Q03321

PROPOSAL DRAWING

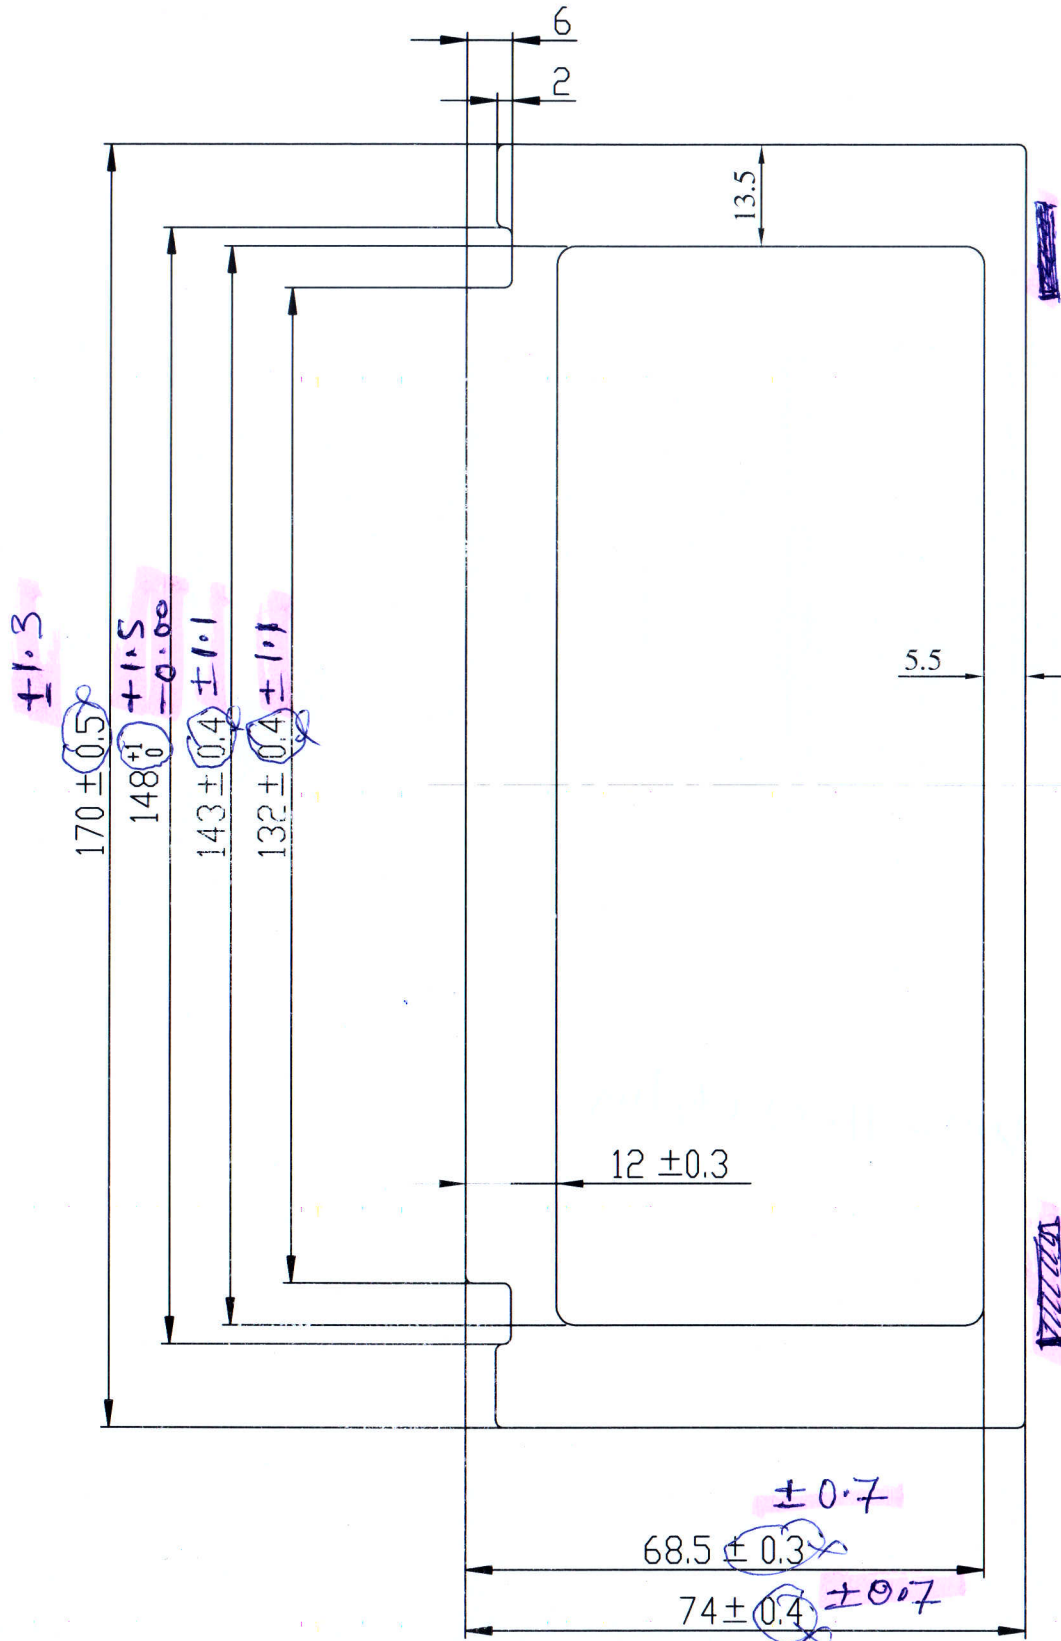
DUE TO THICKNESS VARIATION
WE MAY GET IMPRESSION
MARKED THESE PLACES
